Access Compliance Report

Public Rights-of-Way

(Curb Ramps)

Intersection ID: 23101	Main Street: LYNBRIDGE_DR	Cross Street: PROVIDENCE_RD	Location: NE
ADA ID: A803DFFDB730	Ramp Type: Perp	Initial Pass/Fail: Fail	Overall Compliance: No
Severity Score: 13.75			
Codes/Mitigation Info/Possible Solution		Field Measurements/Component Compliance

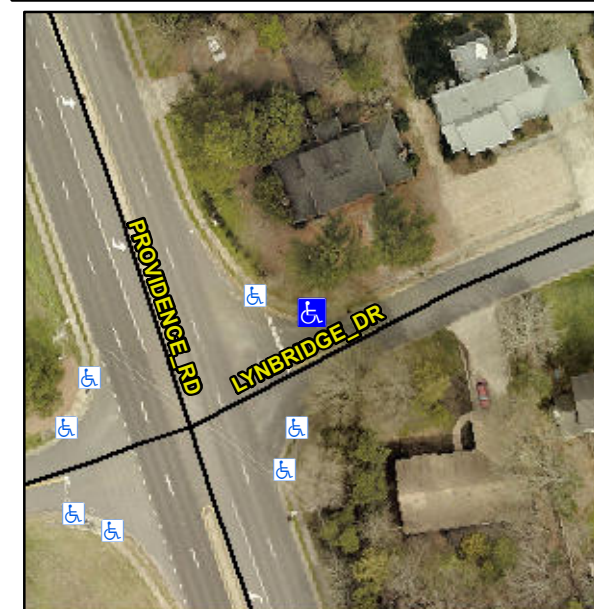
Not Found, R304.2.2, R304.5.3

Compliance	Description	Data	Compliance	Description	Data
N/A	Ramp Length (in)	71.0	No	Ramp Slope (%)	9.5
Yes	Ramp Width (in)	51.0	No	Ramp XSlope (%)	5.0
N/A	Flare Type LT	N/A	N/A	Flare Type RT	N/A
N/A	Flare Slope LT (%)	N/A	N/A	Flare Slope RT (%)	N/A
N/A	Flare Traversable LT?	N/A	N/A	Flare Traversable RT?	N/A
N/A	Landing Length (in)	N/A	N/A	DWS Provided?	N/A
N/A	Landing Width (in)	N/A	N/A	DWS Contrast?	N/A
N/A	Landing Slope (%)	N/A	N/A	DWS Length (in)	N/A
N/A	Landing X Slope (%)	N/A	N/A	DWS Full Width?	N/A
N/A	Landing Curb? (Y/N)	N/A	N/A	DWS Offset (in)	N/A
N/A	Shared Landing?	N/A			
N/A	Gutter Ponding?	N/A	N/A	Gutter Slope (%)	N/A
N/A	Gutter Lip Ht (in)	N/A	N/A	Gutter X Slope (%)	N/A
N/A	Painted X Walk1?	No	N/A	Painted X Walk2?	N/A
	X Walk 1 Direction	To SW		X Walk 2 Direction	N/A
N/A	X Walk 1 Width (in)	N/A	N/A	X Walk 2 Width (in)	N/A
	X Walk 1 Slope (%)	1.3		X Walk 2 Slope (%)	N/A
	X Walk 1 X Slope (%)	4.3		X Walk 2 X Slope (%)	N/A

Remove & Replace Entire Ramp.
